Access Compliance Report

Public Rights-of-Way

(Curb Ramps)

Intersection ID: 21723	Main Street: BALLENCOURT_LN	Cross Street: COLONY_RD	Location:	N
ADA ID: E0CC0B0C226A	Ramp Type: BlendTrans2	Initial Pass/Fail: Fail	Overall Compliance: No	Severity Score: 47.5

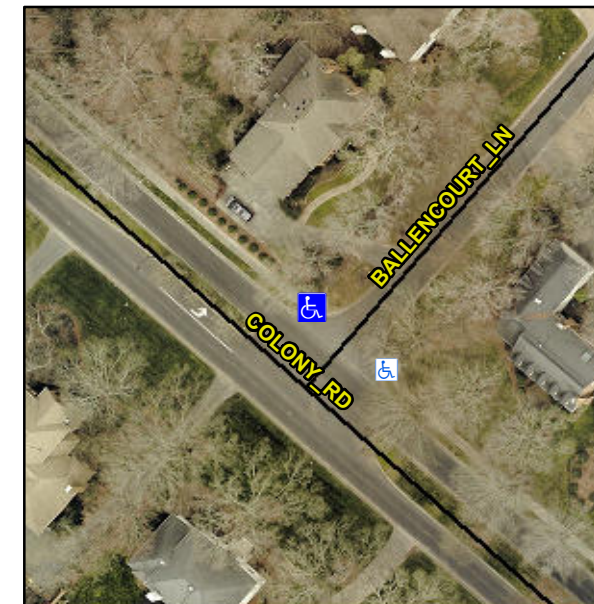
Not Found, R304.5.1, R304.5.3

Compliance	Description	Data	Compliance	Description	Data
N/A	Ramp Length (in)	96.0	Yes	BlendTrans Slope (%)	4.7
No	Ramp Width (in)	30.0	No	BlendTrans XSlope (%)	5.2
N/A	Flare Type LT	N/A	N/A	Flare Type RT	N/A
N/A	Flare Slope LT (%)	N/A	N/A	Flare Slope RT (%)	N/A
N/A	Flare Traversable LT?	N/A	N/A	Flare Traversable RT?	N/A
N/A	Landing Length (in)	N/A	N/A	DWS Provided?	N/A
N/A	Landing Width (in)	N/A	N/A	DWS Contrast?	N/A
N/A	Landing Slope (%)	N/A	N/A	DWS Length (in)	N/A
N/A	Landing X Slope (%)	N/A	N/A	DWS Full Width?	N/A
N/A	Landing Curb? (Y/N)	N/A	N/A	DWS Offset (in)	N/A
N/A	Shared Landing?	N/A			
N/A	Gutter Ponding?	N/A	N/A	Gutter Slope (%)	N/A
N/A	Gutter Lip Ht (in)	N/A	N/A	Gutter X Slope (%)	N/A
N/A	Painted X Walk1?	No	N/A	Painted X Walk2?	No
	X Walk 1 Direction	To SW		X Walk 2 Direction	To SE
	X Walk 1 Width (in)	N/A		X Walk 2 Width (in)	N/A
	X Walk 1 Slope (%)	5.4		X Walk 2 Slope (%)	3.1
	X Walk 1 X Slope (%)	4.2		X Walk 2 X Slope (%)	3.3

N/A	Ramp inside XWalk1?	N/A	N/A	Ramp inside XWalk2?	N/A
	Road Slope (%)	7.6		Clear Space?	N/A
	Road X Slope (%)	1.9	N/A	Clear Space to XWalk (in)	N/A
N/A	Any Obstructions?	N/A	N/A	Storm Grate/Utility Hazard?	N/A
	Obstruction Type			Storm Grate/Utility Type	
		N/A			N/A
			Yes	Surface Condition? (G/P)	Good
			No	Curb Slope (%)	10.8

Remove & Replace Curb Ramp With Two New Directional Ramps or Equivalent.
